NUMBER: 18-095-15

THIS BULLETIN SUPERSEDES SERVICE BULLETIN 18-022-15 REV. B, DATED SEPTEMBER 29, 2015, WHICH SHOULD BE REMOVED FROM YOUR FILES. ALL REVISIONS ARE HIGHLIGHTED WITH **ASTERISKS AND INCLUDE ADDITIONAL DTCs, REPAIR PROCEDURE AND NEW LOPS.**

Flash: 3.0L Powertrain Diagnostic And System Enhancements

2015 (WK) Jeep Grand Cherokee

Fig. 1 EGT Sensor Bank 1 Sensor 1

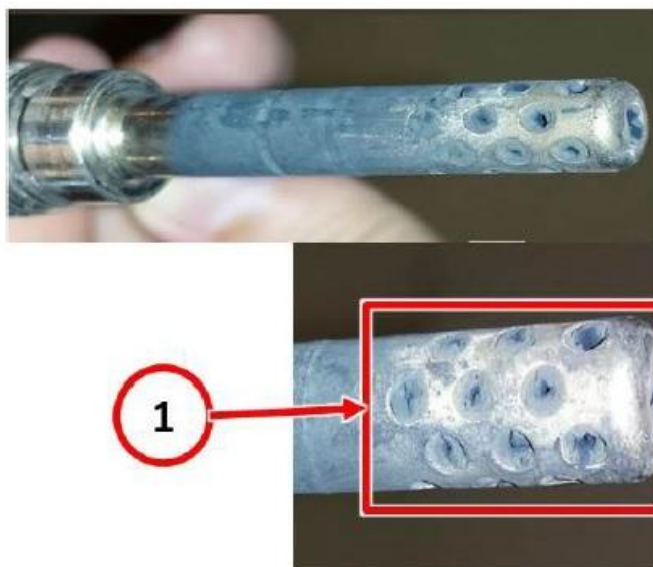
11. Inspect the sensor body and probe for any signs of damage or excessive soot. See (Fig. 1).

1 - Excessive soot blocking sensor ports

-
12. Was excessive soot found on the sensor?
- Yes>>> Proceed to [Step #13](#).
 - No>>> Proceed to [Step #14](#).
13. Using shop air set to a maximum of 80 psi, clean all excessive soot from the sensor probe.

14. Using a suitable multi-meter with appropriate test probes, test the resistance between the sensor connector terminals 1 and 2. With the sensor at room temperature, 65-75 °F (18-25 °C), the resistance should measure between 200 and 240 ohms.

15. Is the temperature sensor resistance within specifications?
- Yes>>> Install the original EGT sensor 1/2 and/or Catalyst Temperature Sensor. Refer to detailed installation procedures available in DealerCONNECT> TechCONNECT> Service Info Section 11 - Exhaust System> Sensor, Exhaust Temperature> Installation> Exhaust Gas Temperature Sensor 1/2.

- No>>> Install a new EGT sensor 1/2 and/or Catalyst Temperature Sensor. Refer to detailed installation procedures available in DealerCONNECT> TechCONNECT> Service Info Section 11 - Exhaust System> Sensor, Exhaust Temperature> Installation> Exhaust Gas Temperature Sensor 1/2.
